CLASS I SERVICE INSTRUCTIONS

No. 1038, Rev I
ATA Code 24-30

SUBJECT: ELECTRICAL POWER - MODIFICATION OF ELECTRICAL SYSTEM AND IMPROVED ALTERNATOR PARALLELING

SYNOPSIS OF CHANGE: Reversed steps 7i and 7j under ACCOMPLISHMENT INSTRUCTIONS to correct check procedure.

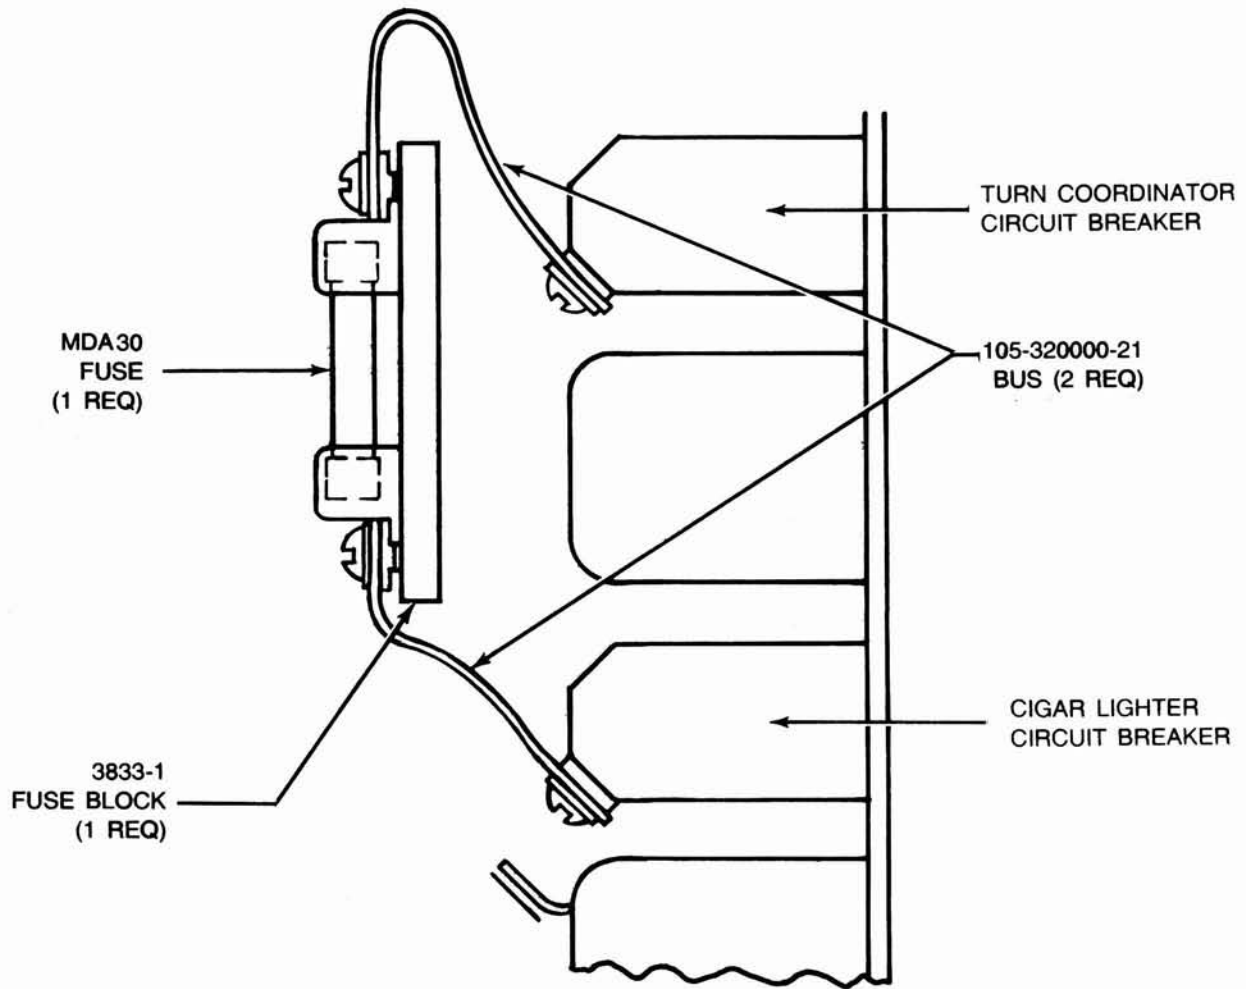
1. Turn off and/or disconnect battery and all other electrical power.
2. Install a P/N 3833-1 fuse block and an MDA30 fuse between the No. 1 and No. 2 circuit breaker buses behind the RH subpanel using two P/N 105-320000-21 bus ties as shown in the illustration.

The P/N 105-320000-21 bus ties may be hand formed as necessary to facilitate installation as shown in the illustration.
